Valley – Ivyglen Subtransmission Project CPUC Minor Project Refinement Form

Date Requested: 6/15/2021

Proposal for Additional Work Areas and Disturbances:

Figure 1. Proposed Areas of Excavation (white polygons) Between 454E and 460E.

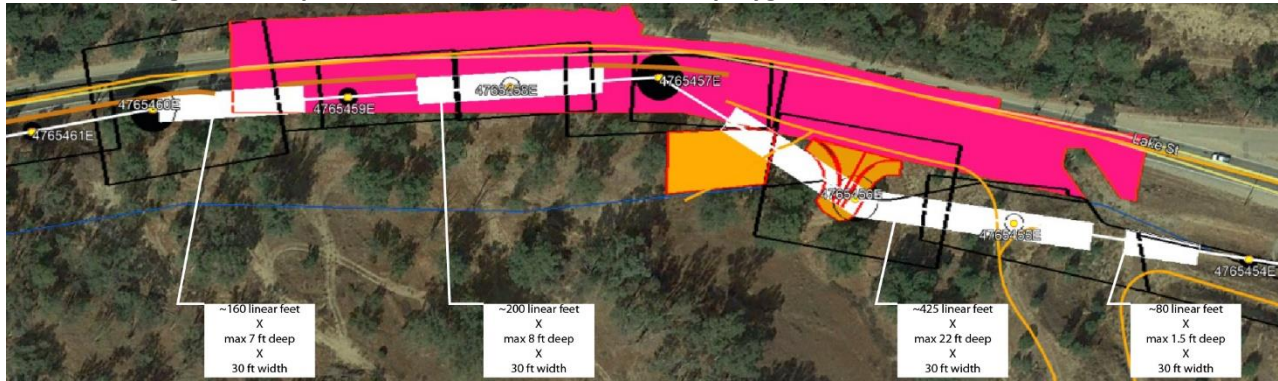
In coordination with the landowner and the City of Lake Elsinore, soil excavation is proposed between 454E and 460E to accommodate the future realignment of Lake Street. The planned Lake Street

realignment will parallel the Valley-Ivyglen subtransmission line and will be constructed at an elevation similar to the existing Lake Street. The current ground elevation along the Valley-Ivyglen alignment is as much as 30 feet higher than the future elevation. In order to avoid future modifications to the Valley-Ivyglen line, the Project proposes to excavate soil at 455E, 456E, 458E, and 460E so the structures can be installed at the required future ground elevation. Additionally, where needed, the Project proposes to excavate 30-foot-wide swaths (Figure 1) underneath the path of the 115 kV conductor from 454E–460E to lower the ground elevation between structures and provide necessary ground clearance for the conductor and telecommunication wire. The depth of the excavations would vary as necessary to reach the future roadway elevation and would be as deep as 22 feet at 455E.

Following the completion of all construction, the temporary work areas would be restored/reclaimed in accordance with the Project SWPPPs, Project Commitment D, and the VIG Habitat Restoration and Revegetation Plan. For excavations between 454E–460E, restoration would include grading final slope of no steeper than 3:1 and installing straw wattles along the slopes as required by the SWPPP.

Erosion would be controlled at locations of earth disturbance through the implementation and adherence to the Project linear SWPPP. The VIG LUP SWPPP would be amended to reflect the excavation activities and subsequent stabilization of soils from 454E to 460E. At the completion of all construction, sites would be restored/reclaimed in accordance with the Project SWPPPs, Project Commitment D, and the VIG Habitat Restoration and Revegetation Plan. Restoration for excavated areas from 454E to 460E would include grading to a final slope of no steeper than 3:1 and installing straw wattles along the slopes at 6-foot spacing.
